Results of Independent Testing of SFEI's Multibox Model for PCB Fate and Transport

Prepared For:
Clean Estuary Partnership

Prepared by:
 Tetra Tech, Inc.
Lafayette, CA

September 2, 2005

Figure 23. Year 1999 average and range of layer 2 daily predicted suspended solids concentrations at locations around the Bay.

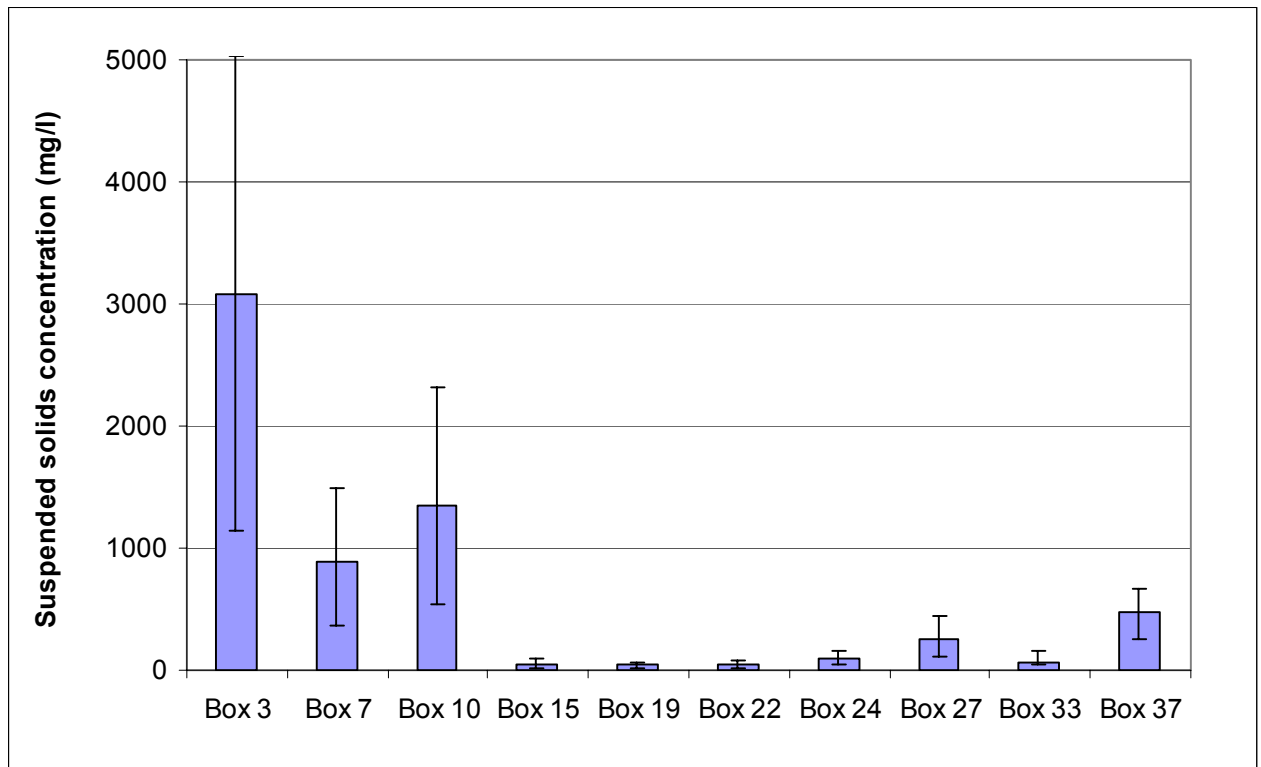
Figure 23 shows representative results for 10 boxes throughout the Bay, from Lower South Bay to Suisun Bay for the year 1999. These results again show high suspended solids concentrations in the South Bay, which dramatically decrease by box 15 in the Central Bay. It is suggested that implications of the high concentrations of suspended solids in the lower layer in the South Bay on PCB fate and transport be examined.

Figure 24. Bed elevation changes at selected locations in the Bay.

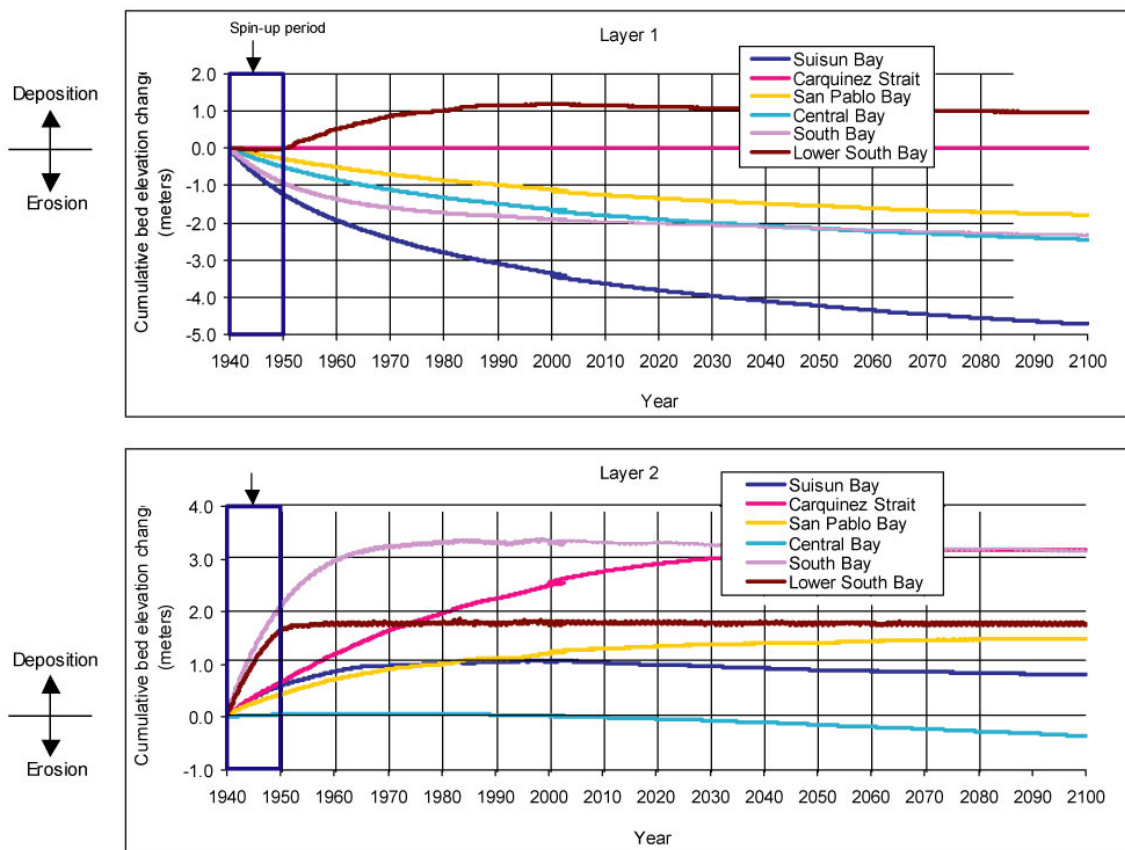
The second part of the UPS review focuses on predicted changes in bed elevations, and predicted cumulative amounts of erosion and deposition at locations where estimates have been made of sediment deposition and erosion. Figure 24 shows cumulative predicted bed elevation changes at six locations around the Bay, from Lower South Bay to Suisun Bay. The feature that is of most interest here is the rapid changes that occur during the first ten years or so following the beginning of model simulations. These rapid changes appear to be a manifestation of model adjustments to the initial conditions, as it appears that the model predicted bed elevation changes are much more gradual later in the simulations. This suggests, as discussed earlier, that if this phenomena is model-generated and not a feature of the Bay, that an adjustment in the spin-up period should be made to prevent this from impacting model predictions.

Figure 27. Comparison of observed data to MBM-predicted total water column PCB concentrations over hindcast and forecast periods.

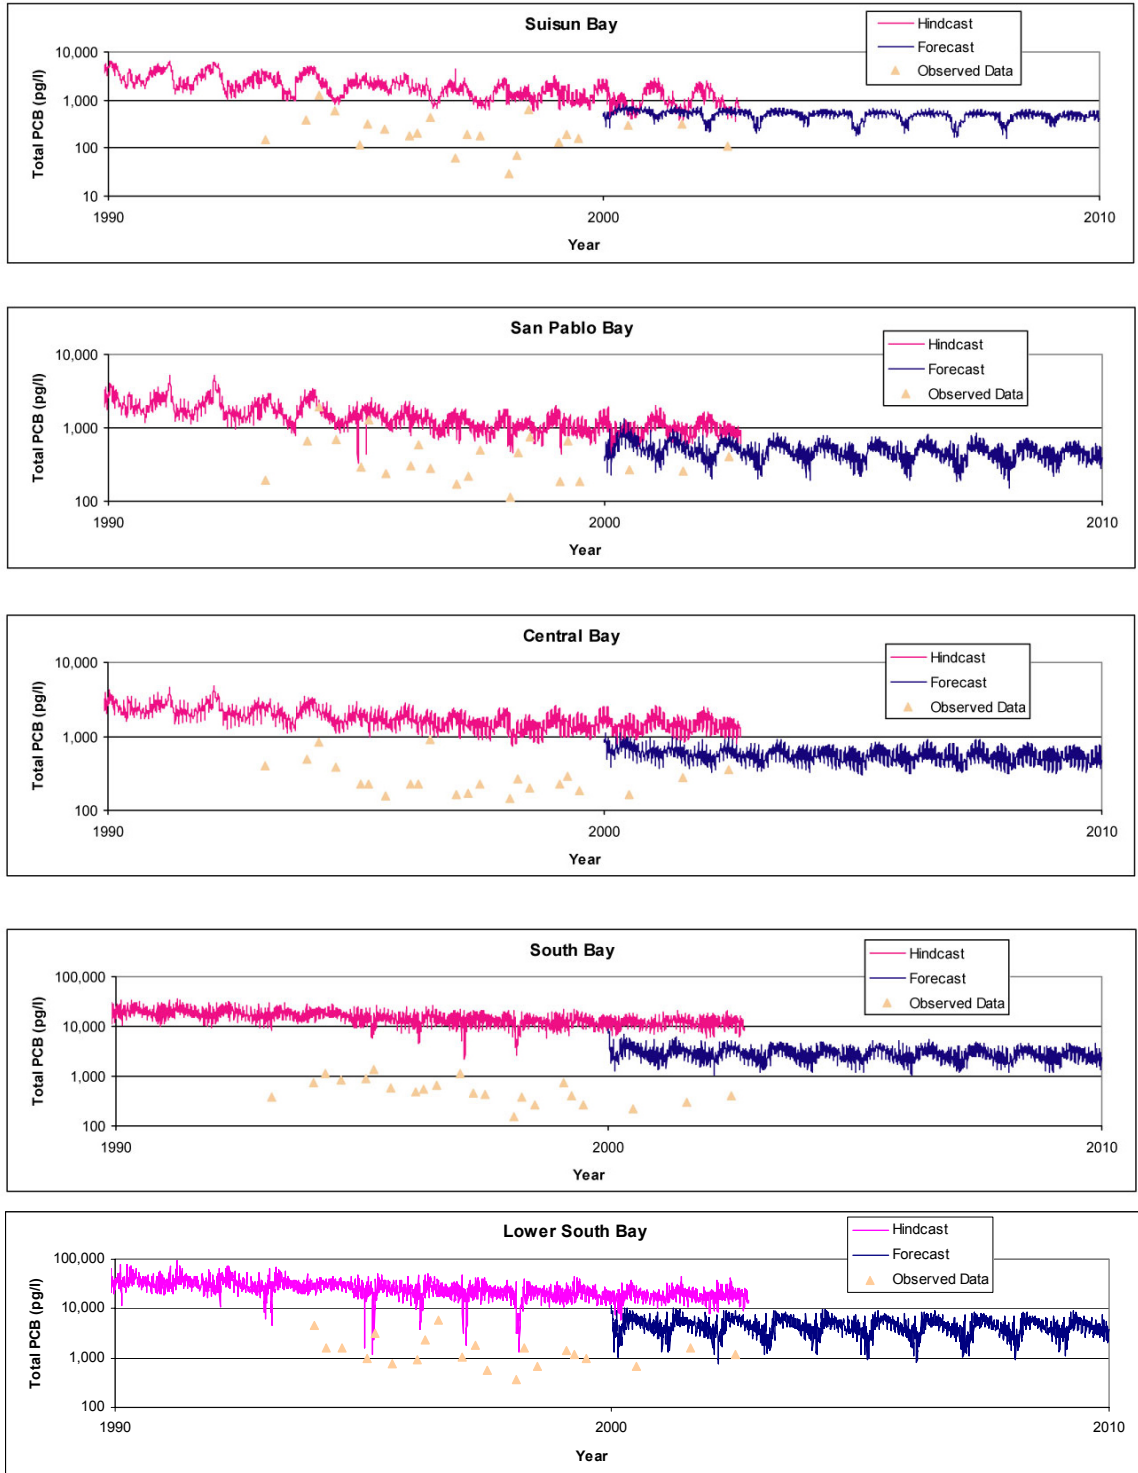
In this section, comparisons are made between observed and predicted PCB concentrations in the water column (both total and dissolved) and in the sediments. The results appear to show that the predicted concentrations in both water and sediments generally exceed observations. To illustrate this, Figure 27 shows the predicted one-day average total PCB concentrations during the hindcast and forecast periods, along with the mean of observed data. Locations shown are for Suisun Bay, San Pablo Bay, Central Bay, South Bay, and Lower South Bay. In all cases, the hindcast predictions exceed the observations, typically by a factor of 5 to 10 times. The figures also illustrate the scaling that was performed in the surface sediment for the forecast to bring the predictions into agreement with observed data.

Figure 28. Comparison of Year 2000 measured and predicted PCB concentrations – dissolved and surface sediment.

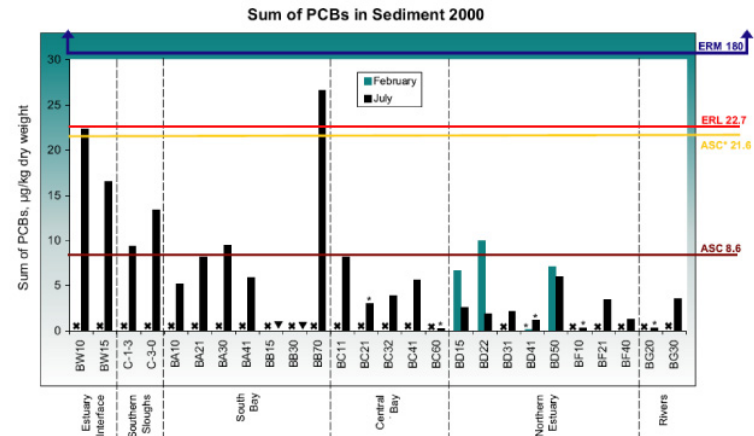
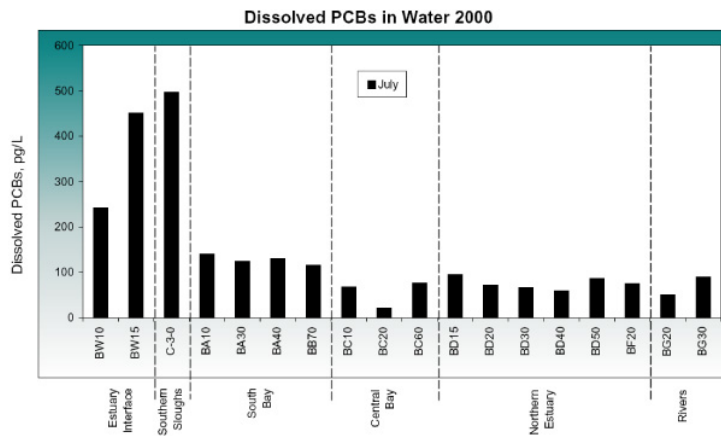
Figure 28 shows predicted dissolved water column PCB concentrations for year 2000 at three locations (Lower South Bay, Central Bay, and San Pablo Bay) for both upper and lower layers, and RMP data for comparison. The predicted values exceed observations by about 3 to 10 times. In the surface sediments, the same results apply, where higher than observed surface PCB concentrations are predicted. A depth profile of sampled PCBs in 1990 (from Venkatesan et al, 1999) was plotted against predicted profiles for 1970 and 1990 (see Figure 29). Based on the bathymetry of San Pablo Bay, the 1990 profile is located in the channel; it exceeds the observed profile data by 5 to 10 times. It is noted that the predictions for 2010 in the channel match the data for Venkatesan et al. (1999); because of the scaling, these data more closely match observed data. It is suggested that the need for this scaling be eliminated by determining the cause of the generally elevated predictions for PCBs. One cause could be that in the model, larger historical PCB loadings are input to the Bay than actually occurred (see the following section).

Figure 30. Depth profiles of PCBs in Lower South Bay sediments.

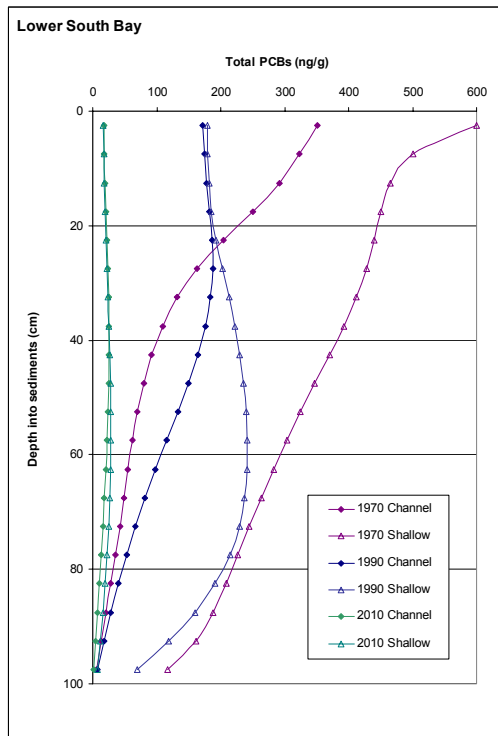
A second figure for predicted sediment PCBs over depth is shown in Figure 30. Predicted results during the hindcast period range from 200 ng/g to 600 ng/g near the surface to less than 200 ng/g near the 100 cm depth. Based on near-surface PCB measurements in the Lower South Bay (10 ng/g to 25 ng/g) the predictions over-estimate observations by a factor of 10 or more. Again, the data shown for 2010 are subsequent to the forecast scaling.

Figure 31. Total PCB loads to Bay based on approach from V.1 draft report.

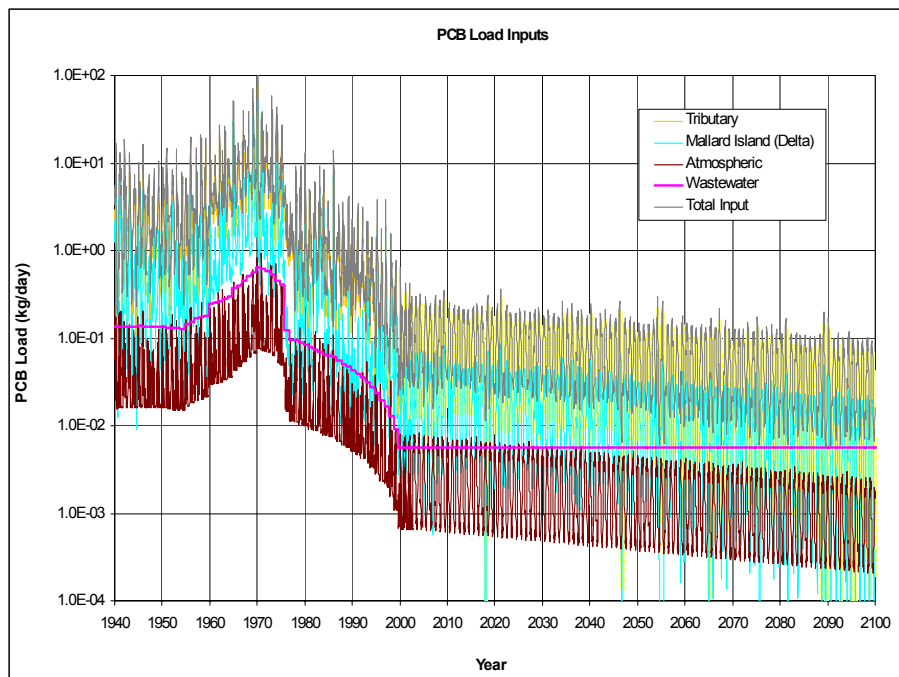
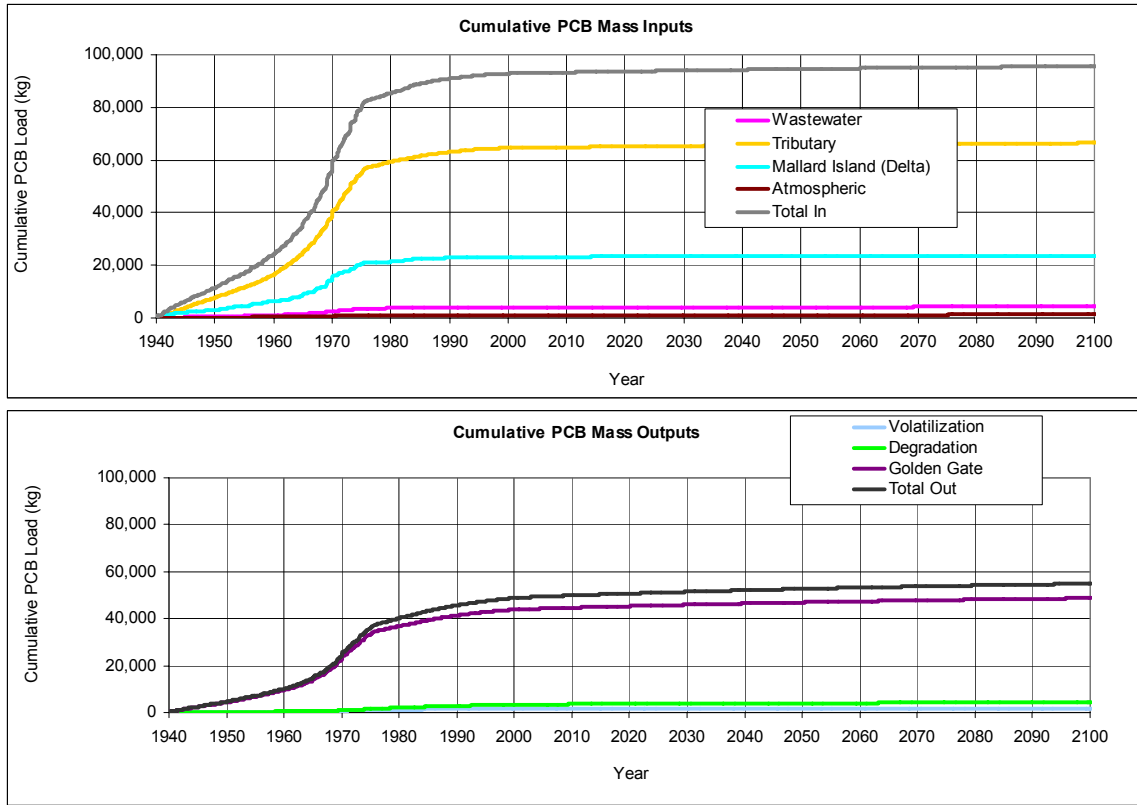
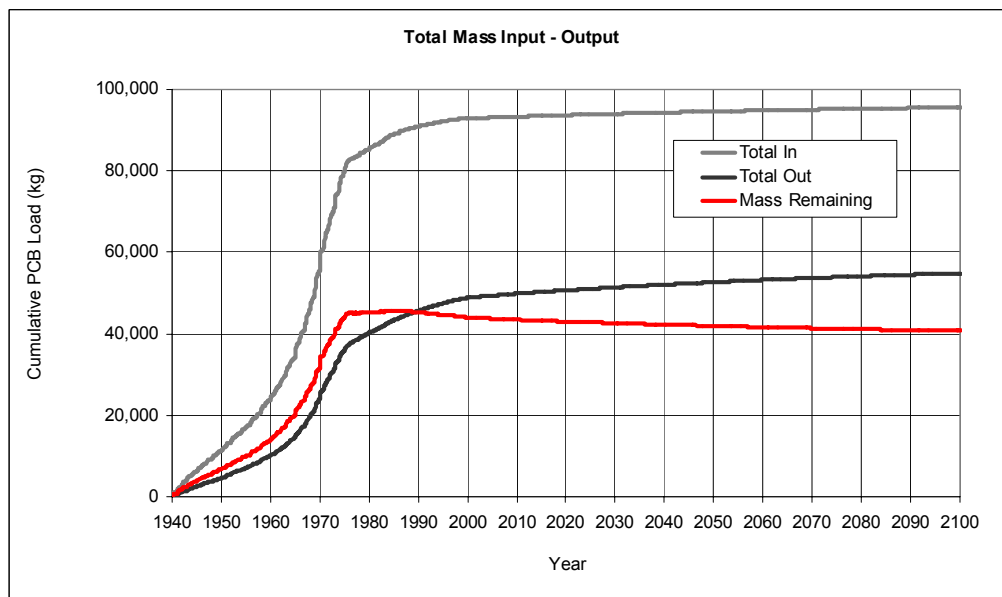
Figures 31, 32, and 33 were constructed to verify that the loading estimates to the Bay are consistent with the estimates in the draft report, and that the PCB mass within the Bay is declining over time. Based on calculations performed during this review, these observations are true. Several issues are apparent from these figures:

- PCB loading to the Bay by 1940, according to Figure 31 was quite large, perhaps an order of magnitude greater than today. Thus, it is likely that there would have been significant quantities of PCBs in the Bay by then. Thus, setting sediment PCB levels to zero in 1940 is probably not realistic.

- Since about 1990, according to the model, the total amount of PCBs remaining in the Bay is decreasing. To reduce (or remove) the dependence of model predictions on the highly uncertain loading reconstruction, an alternative approach to initializing the model could be to use the coring data to be collected in 2005 and estimates of present and future of PCB loads, rather than trying to recreate such a long hindcast period. Figure 34a illustrates a factor of 10 load change for PCBs to the Bay over the hindcast and forecast periods. This range is the same chosen by Breivik in Figure 8 of the draft report. The hindcast and forecast total PCB concentrations in the water column for the Lower South Bay and Suisun Bay are superimposed on the PCB load in Figure 34b. It is clear from this figure that the predicted concentrations respond very strongly to loading changes. This indicates that, should evidence support significant decreases in loading, predicted concentrations could be much more in-line with observations.

In contrast, according to the MBM over 40 percent of the PCB-118 discharged is predicted to remain in the Bay today (see Figure 33). The more heavily chlorinated PCBs would likely be present at even higher percentages than PCB-118. Suggestions to address these issues are:
